City of Richmond
Planning and Development Department

Report to Development Permit Panel

To: Development Permit Panel
From: Brian J. Jackson, MCIP
Director of Development
Date: October 7, 2010
File: DP 09-494270
Re: Application by Matthew Cheng Architect Inc. for a Development Permit at 8091
and 8131 No. 2 Road

"That Development Permit application 09-494270 be deferred to the next Development Permit Panel meeting scheduled for Wednesday, October 13, 2010 at 3:30 p.m. in the Council Chambers at Richmond City Hall, for the purpose of further exploration of planting and articulation along the driveway."

LOT COVERAGE PLAN
 SHEET NO. L3
 OF 5
 PROJECT NUMBER: 09-098

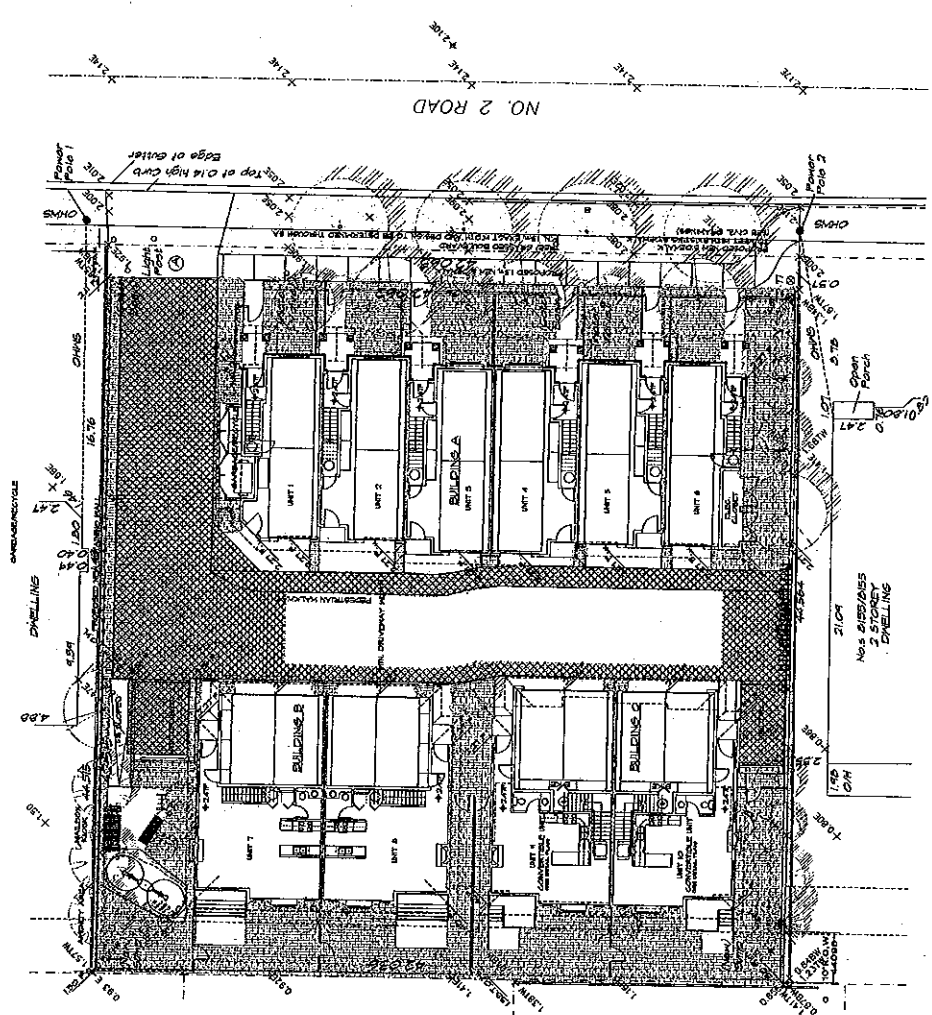
2) To reduce the lot coverage for landscaping with live plant material from 30% to 22%.

(Staff supports the proposed variance as permeable pavers are proposed to cover 16.6% of the lot area so that the total porous surface including live plant material is 39.2%. The landscape plan also maximizes on-site tree replacement and conforms to the design guidelines in the OCP for multi-family development).

- The proposed lot coverage for landscaping with live plant material (22%) is lower than the minimum required under the RTM3 zoning (30%), for which the applicant is requesting a variance. Permeable pavers are proposed, however, to cover 16.6% of the lot area so that the total porous surface is 39.2%.

In addition to the increase in live plant material provided by the landscaped strip along the drive aisle, the applicant has proposed changes to incorporate additional soft landscaping within rear yards of Buildings B and C, and between garage aprons to increase the overall live plant material coverage from 22% to 25%. This results in a decrease to the extent of the requested variance. Staff are supportive of the revised variance request given the effort taken by the applicant to revise the proposed site plan which has resulted in a decrease to their overall floor area ratio from 0.66 to 0.65.

COVERAGE WITH LIVE PLANT MATERIALS
 4795.3 sq.ft. (1449.63 sq.m.) 25.14%

DP 09-494270
 PLAN # 3A

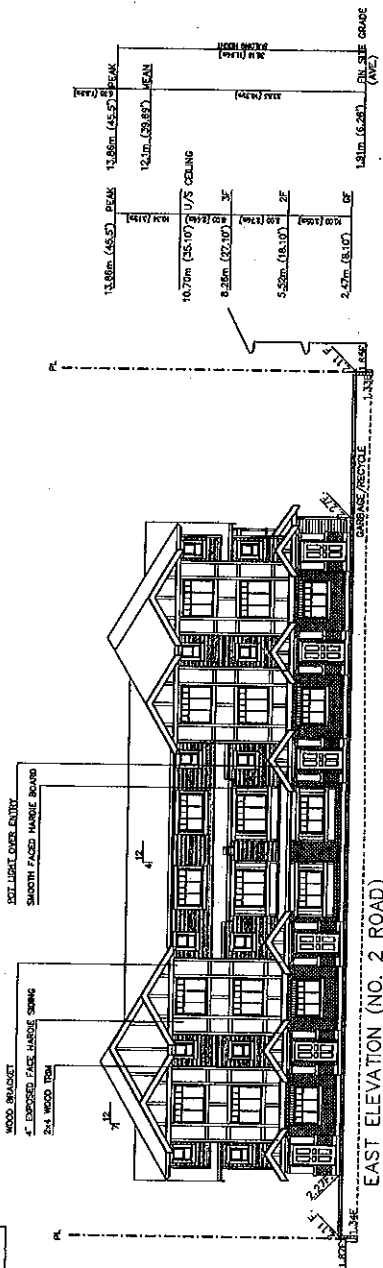
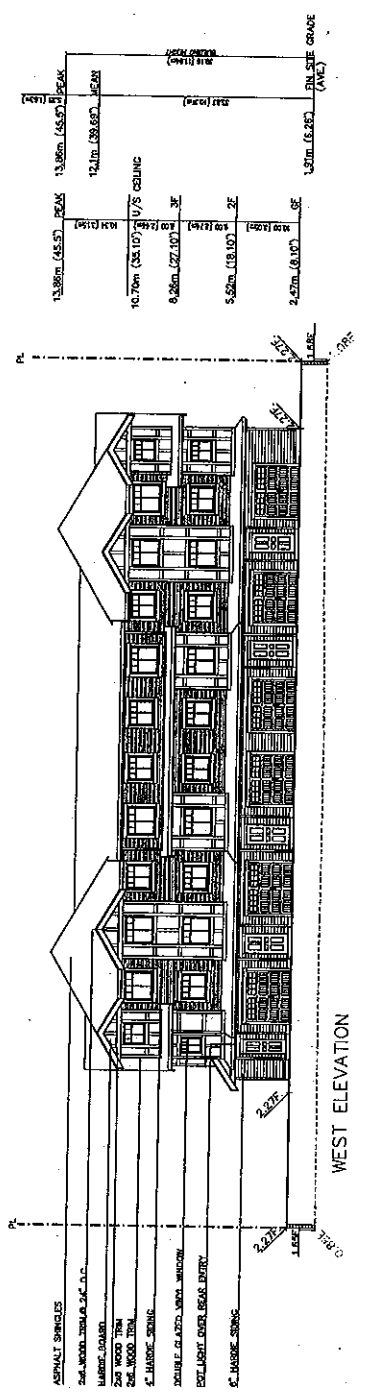
2. Design development to colour palette to increase richness and accent;
Along No. 2 Road, the colour palette has been revised to consist of red bricks with darker trims against the light hardie board and heritage bluish-grey hardie siding. Buildings B and C are with the same colour palette without the brick.

3. Design development to improve the relationship between the colours and materials and increasing visual differentiation among the different materials;
Please see the revised colour rendering.
